HARTING Product Change Notification

Business Unit: HARTING Electric GmbH & Co. KG
Product range: Han-Modular®
Author: Christine Öhls
Title: Han-Modular® Compact Carrier Hood &
Han-Modular® Compact Bulkhead Mounting Housing

PCN/0036

Date: 20140903

Han-Modular® Compact Carrier Hood 09 14 001 0311:

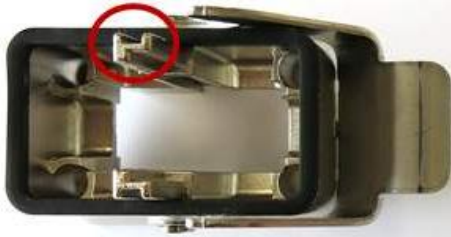
The designs of the Han-Modular® Compact Carrier Hood 09 14 001 0311 and the Han-Modular® Compact Bulkhead Mounting Housing 09 14 001 0301 have been changed.

- The new design has the main advantage of weight reduction as the amount of material is reduced. The weight reduction for both individual parts is approx. 18 g.
- The fixing of the flange gasket is improved as it is stabilized in the hood. This modification ensures easier handling.
- All other mechanical and electrical characteristics remain the same. The parts are 100 % mating compatible. Also prices remain the same.

The revision level of the Han-Modular® Compact Carrier Hood 09 14 001 0311 has been changed from 01 to 02.
